From: KRISTINA BELL <k3m1c@sbcglobal.net>
Sent: Wednesday, May 3, 2023 8:10 PM
To: Gustafson, Nicolas
Subject: [External] Greenhills Ranch Phase II---Concerns

Subject: **Greenhills Ranch Specific Plan Phase II; PDS2016-SPA-16-001; PDS2016-REZ-16-002; PDS2016-TM-5611; PDS2016-ER-98-14-020B**

**Re: Greenhills Ranch Phase II Project including Specific Plan
Amendment (PDS2016-SPA-16-001), Zone
Reclassification/Rezone (PDS2-16-REZ-002), Tentative Tract
Map (PDS2016-TM-5611), Mitigated Declaration – Public
Comments**

I. RESPONSE TO COMMENT MATRIX – GREENHILLS RANCH II

The photos below show the downstairs and upstairs views from inside the homes directly behind lots 7-11.

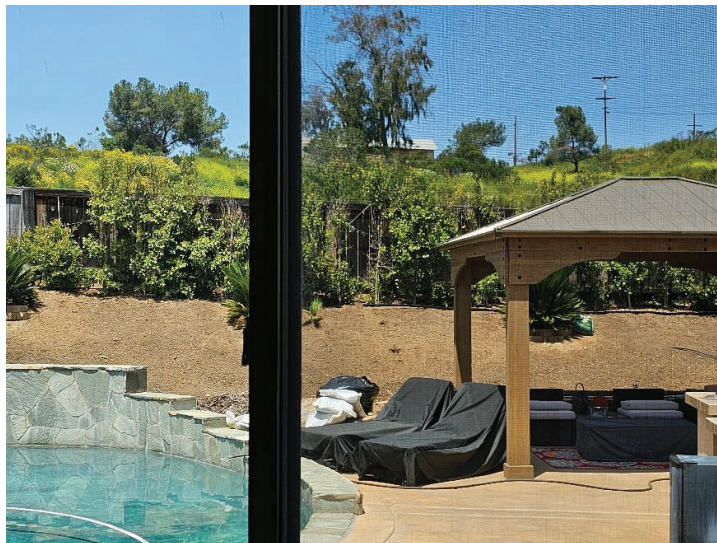
It is uncontested that “the proposed homes would be visible from lower elevation residential areas south of the site.”⁷ The MND attempts to mitigate this by requiring some, *but not all*, of the homes abutting the existing residences to “be restricted to one-story with a maximum height of 20 feet on lots 1-3, 5, 6, 8, 9, 11, 13, and 14. These lots comprise 10 of the 15 lots that face the residential areas to the south along Adlai Road.”⁸ However, the plan proposes to place two-story residences on lots 7, 10, 12, and 15 which are directly behind each of the only four existing residences located on Audubon Road abutting the project. The placement of these two-story residences will be at an elevation higher than the existing residences and cause a substantial change to the existing visual character and quality of the surrounding area as well as a significant impact on the personal privacy of the current residents. Given the higher elevation, people located in these proposed two-story homes will have a direct view to the interior of these existing residences, as well as a view of their backyards where children and adults are often swimming and playing. At a minimum, the MND should require that all lots abutting existing residences (6-15) be one story residences.

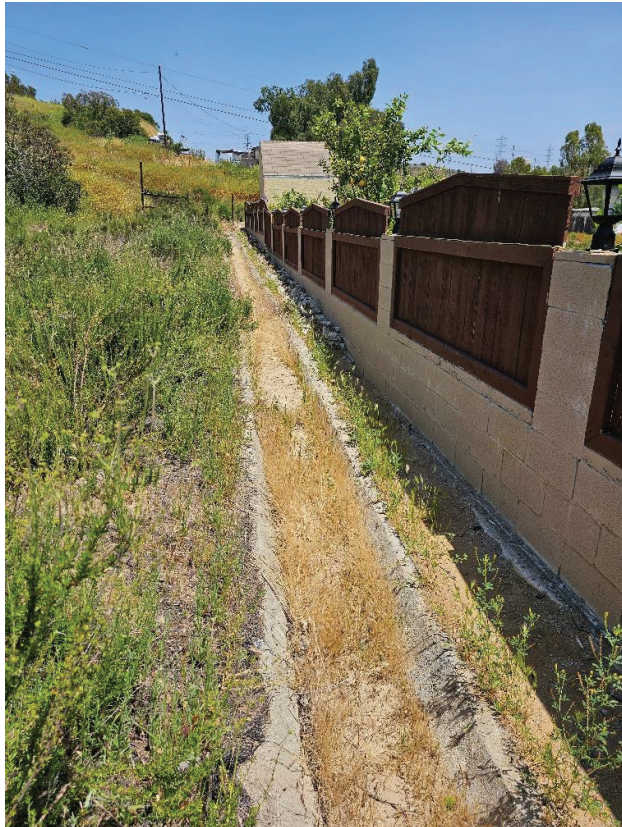
Additionally, the Mitigated Negative Declaration air quality analysis fails to adequately consider the cumulative impacts of the project related to the addition of the Lake Jennings Park Road project site (APN 395-220-11-00), an 18 home development on 5.16 acres currently under construction and located less than a mile from the proposed project site.

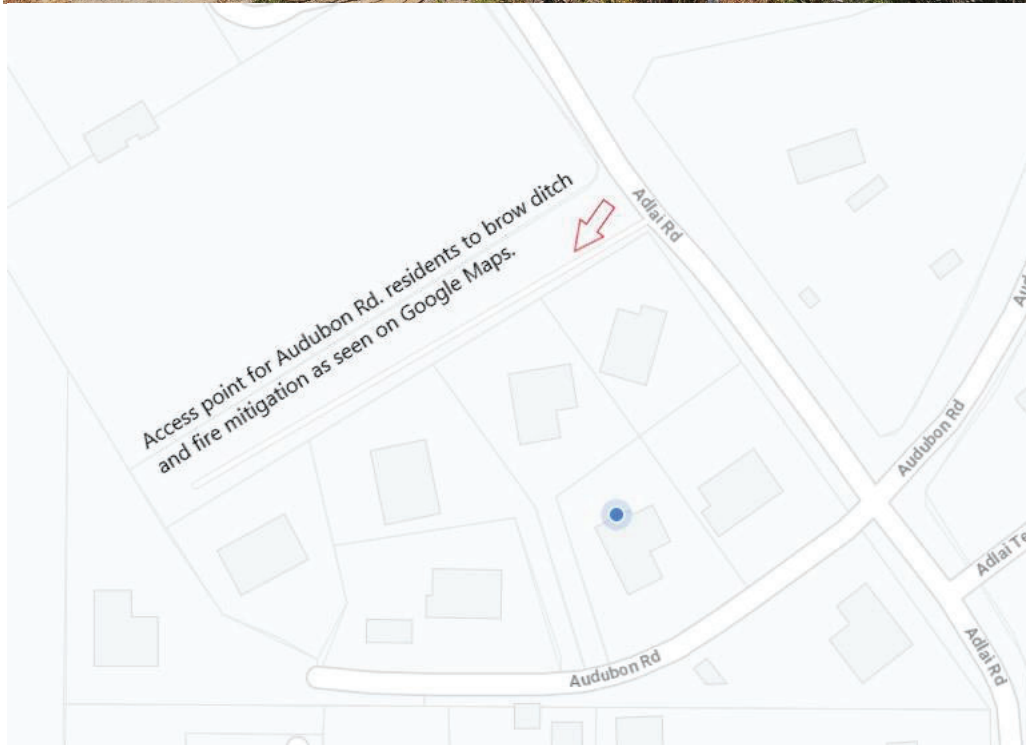
More importantly, the Mitigated Negative Declaration fails to analyze the effect that the change of topography will have on the capacity of the brow ditch. There is also no mention of mitigation efforts to keep the brow ditch clear during construction, and how to prevent debris and runoff from entering the drainage system.

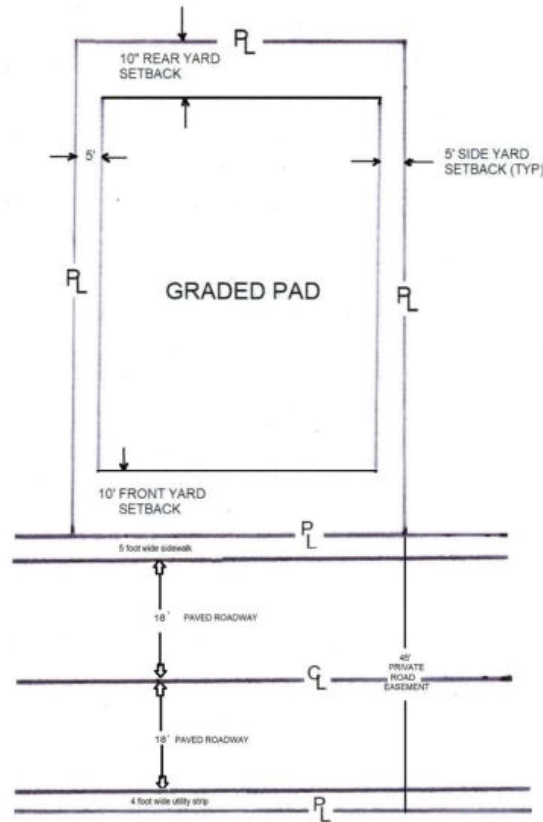
But that is not all, the Mitigated Negative Declaration says nothing about the impacts of changing the setbacks, which this project is also seeking to do.
